## --- ADDENDUM #3 ---

Issued September 3, 2024 to all bidders

# Wolfville AT Connection

CLIENT  
PROJECT DESCRIPTION  
**WOLFVILLE AT CONNECTION**  
WOLFVILLE, NOVA SCOTIA  
SHEET DESCRIPTION

Drawn J. BENEDICT	Engineer E. DALTON	Project No. 23-410	Drawing No. PP-01
Scale 1:250 H, 1:25 V	Filename 23-410_Base - Current.dwg	2 of 10

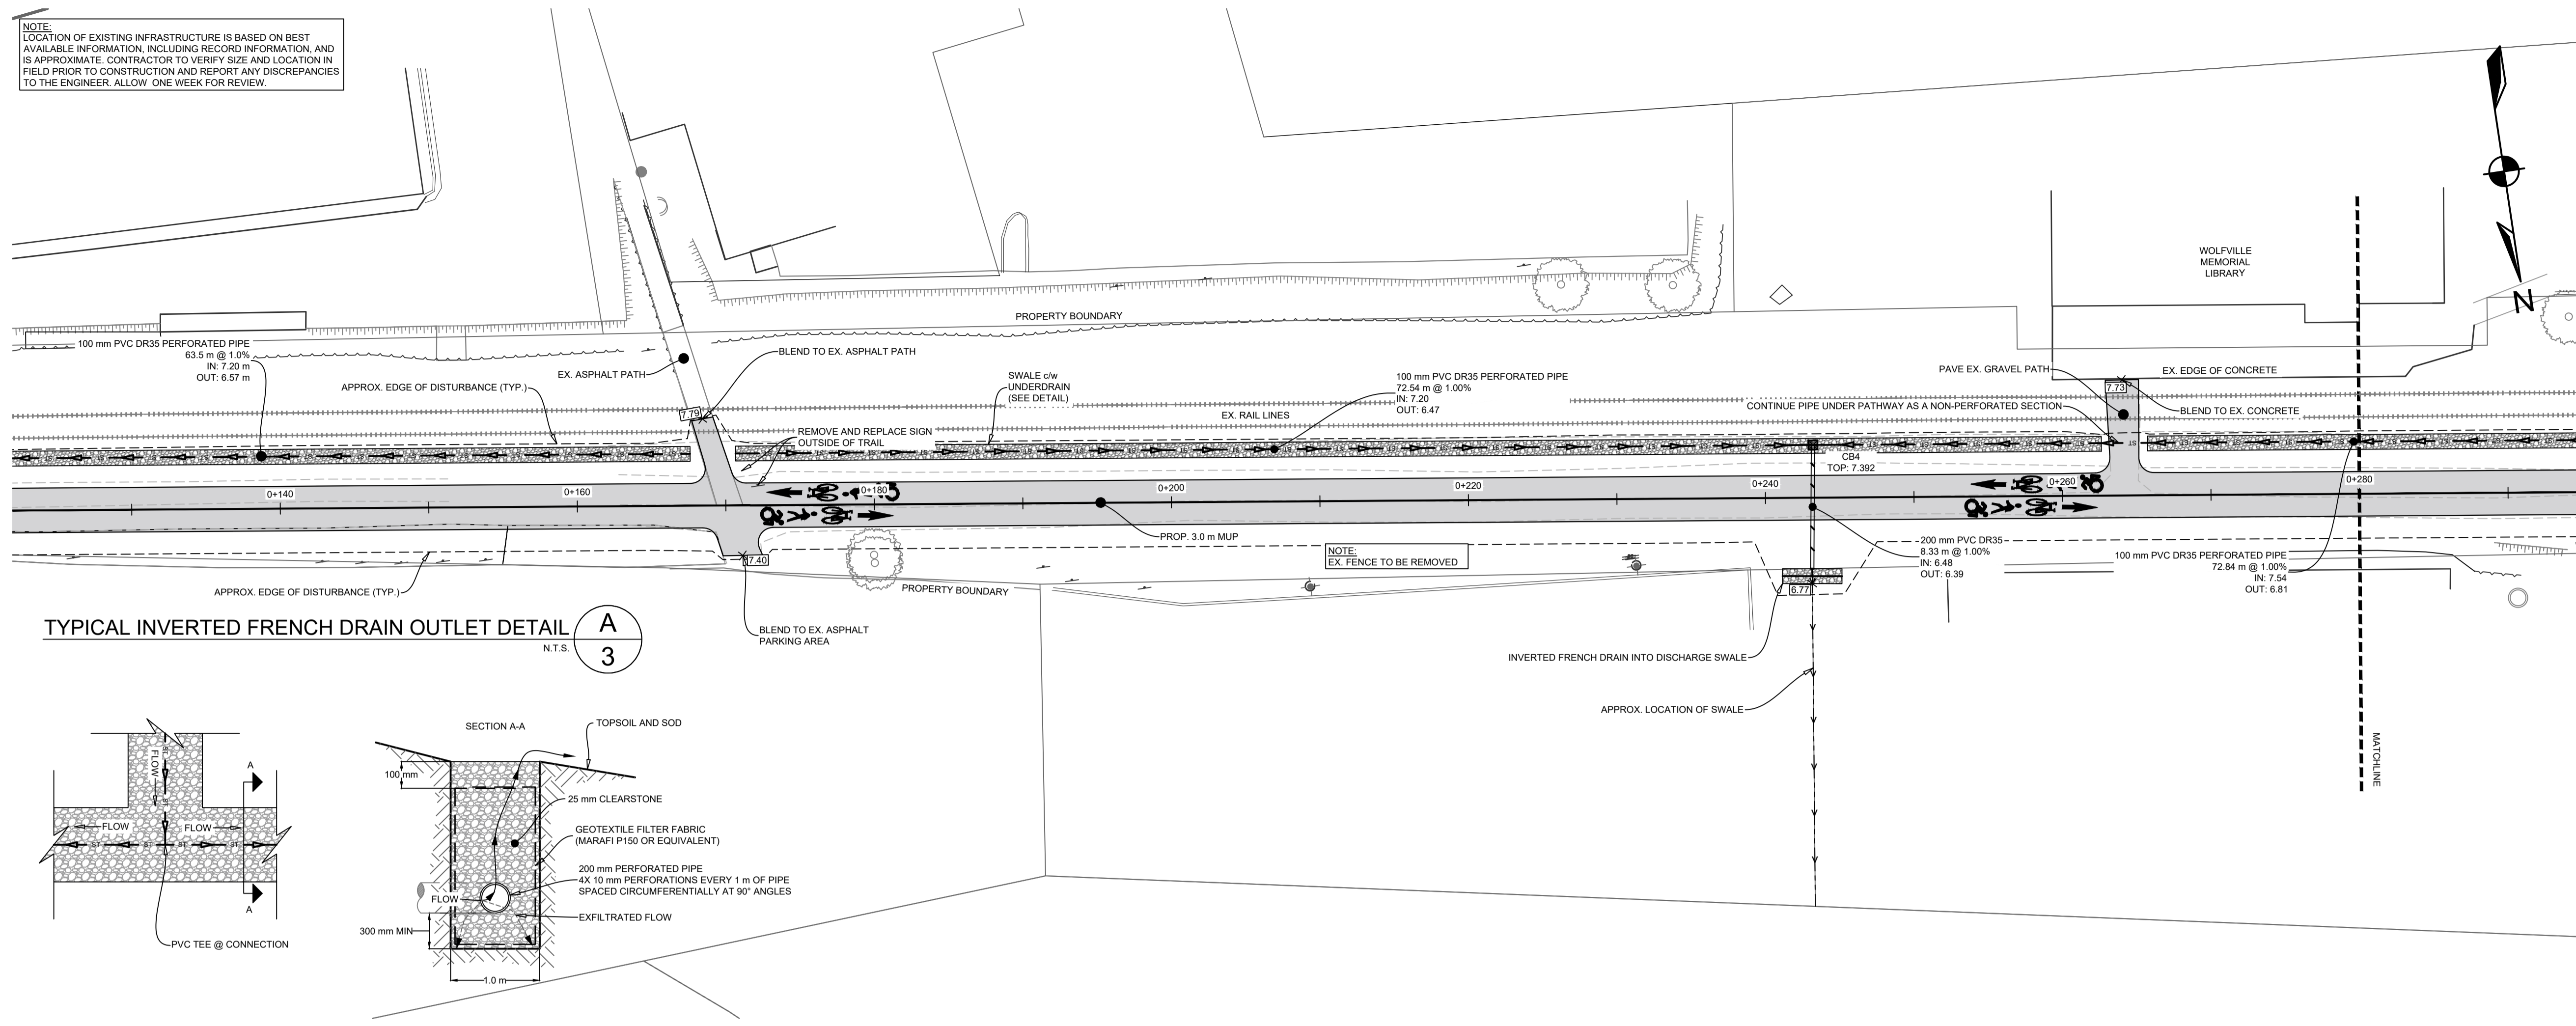
.3 Drawing PP-01 has a note pointing to an existing pole that says, "Add Structs To Ex. Guy Wire For Sidewalk Clearance". This is an item that we are unable to get a price from NSP at this point in the project. Please confirm this will be by owner or an extra to the project? In addition, the summery section of the spec says we are responsible for the relocation of poles and supports, again this is something we can't get a price on from NSP at this point in the project and is also something that's unknown at this point. Please confirm this will also be by owner or an extra to the project if required?

.6 Drawing PP-01 has a note saying, "Prop Green landing" Is this just a landscaped area? If not, please provide clarification as to what's required? Please also provide a detail?

- .13 Detail A on drawing PP-01 lists MARAFI150 as the acceptable produce for the French Drain geotextile. We would propose using Terrafix 270R as an alternative? Please confirm if this is acceptable?

**a. Contractor is responsible to coordinate all scoping and work with NSPI directly. TOW will issue a letter of authorization for the successful contractor to act on their behalf with NSPI. Any extra costs from NSPI will be forwarded to and paid for directly by TOW.**

**a. This has been removed from the revised drawings.**

- a. **Yes this is acceptable.**
- .14 Detail A on drawing PP-01 has a note pointing to the shoulder on the new trail saying Sod or Gravel. We would need to know if this is gravel or sod. If this is gravel, we will need to know how much of it is gravel and we would need a pay item for this work. Please provide a quantity and pay item if gravel shoulder is required?

Drawn J. BENEDICT	Engineer E. DALTON	Project No. 23-410	Drawing No. PP-04
Scale 1:250 H, 1:25 V	Filename 23-410_Base - Current.dwg	5 of 10

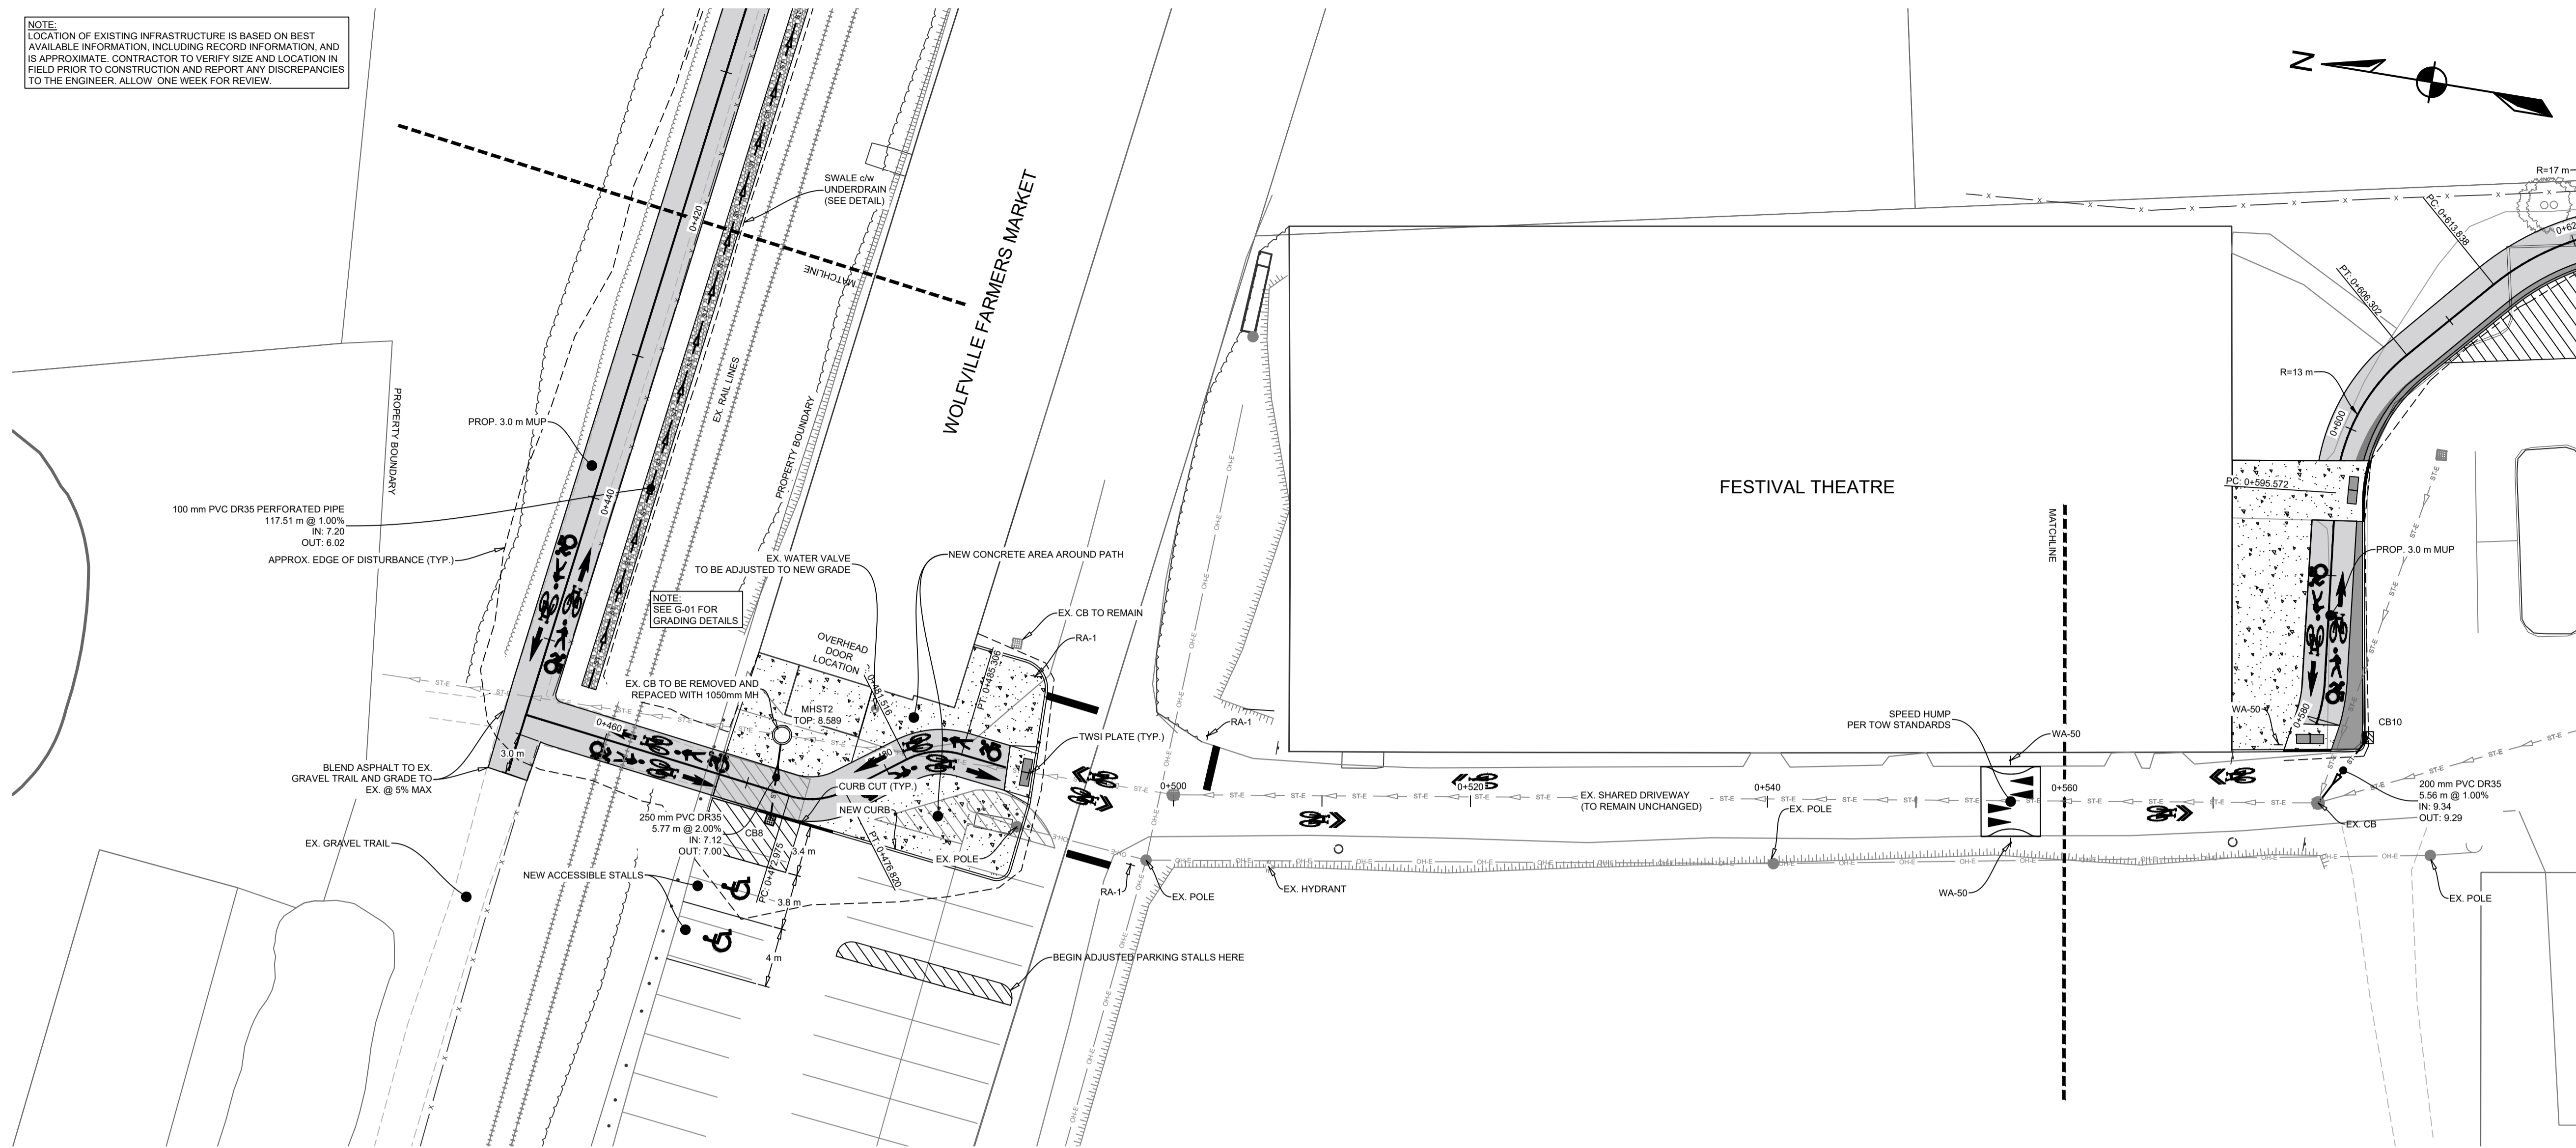
- a. **This has been removed.**
- .24 MHST2 on drawing PP-04 has a note indicating it needs to be raised to new grade and the existing CB cover replaced with a MH cover. There is nothing indicating the size of the existing CB and how much it needs to be raised. Please provide the size and how much it needs to be raised so we can get the required pricing?

- a. **This has been revised to show this structure being replaced with a new MH.**

Drawn	Engineer	Project No.	Drawing No.
J. BENEDICT	E. DALTON	23-410	PP-05
Scale	Filename		
1:250 H, 1:25 V	23-410_Base - Current.dwg		6 of 10

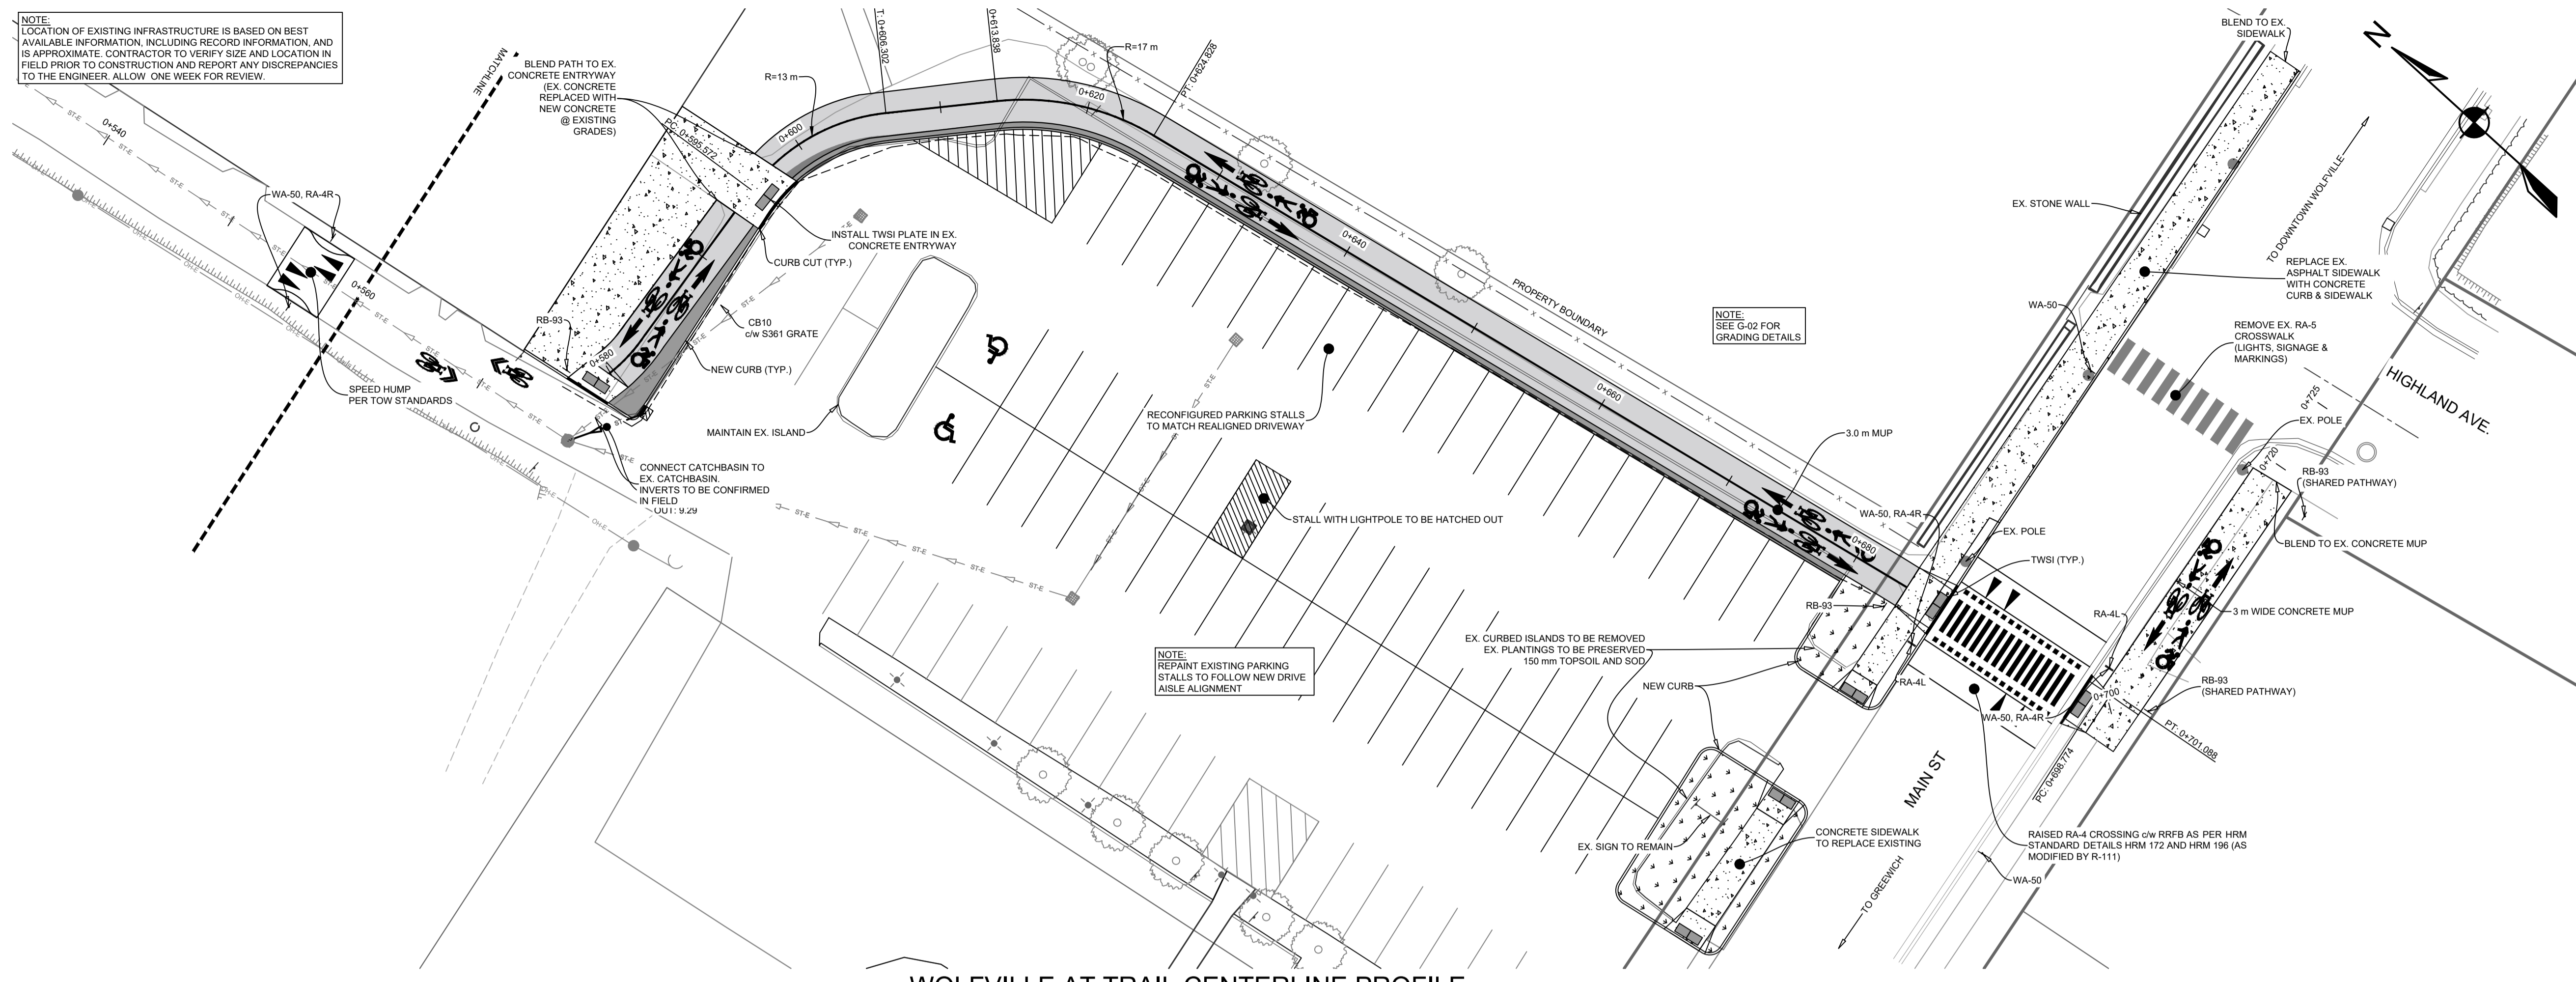
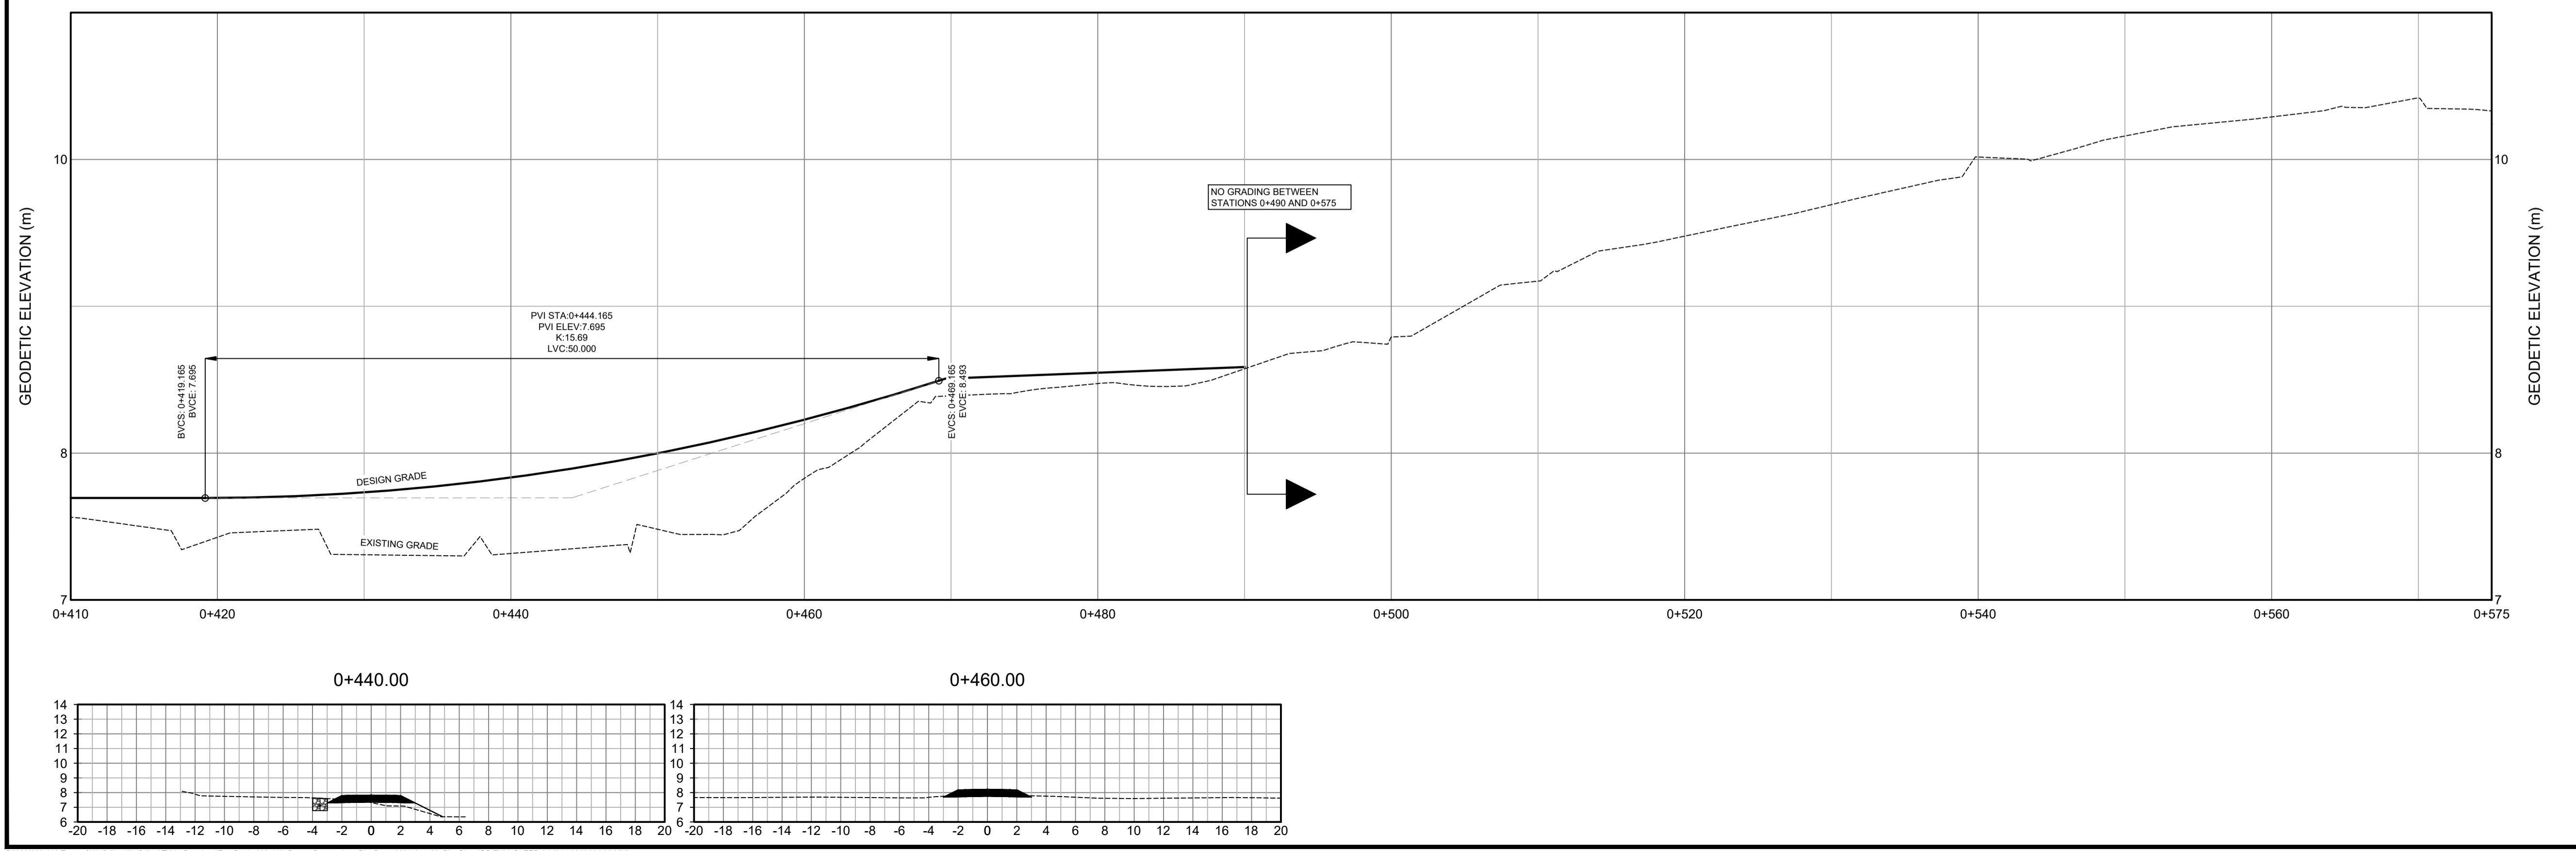
.15 Drawing PP-05 shows a new catch basin (CB10) but it doesn't show any new pipe or indicate how we are supposed to connect this new catch basin to the existing system. Please show the new pipe route and pipe size to connect this to the existing system? In Addition, PP-01 shows a new catch basin as well (CB9) but again it doesn't show any new pipe or indicate how we are supposed to connect this to the existing system. There is a note pointing to this catch basin that says connection to the existing system to be confirmed in field but that being we are unable to accurately price this without any information. Please provide the new pipe route and pipe size to connect the new catch basin to the existing system?

.18 Between station 0+580 and 0+680 on drawing PP-05 it shows a sliver of concrete (Approximately 300mm wide) between the new trail and new curb. This would be an unnecessary cost for the town. Could this be eliminated, and the trail be moved to the backside of the new curb?

**a. Drawing have been updated to show connections and additional detail.**

**a. This has been revised to show the area as asphalt. Item 54 quantity has been revised to include this, and item 60.1b has been added to the tender form to provide a single white edge line to delineate the AT path surface from the paved buffer.**
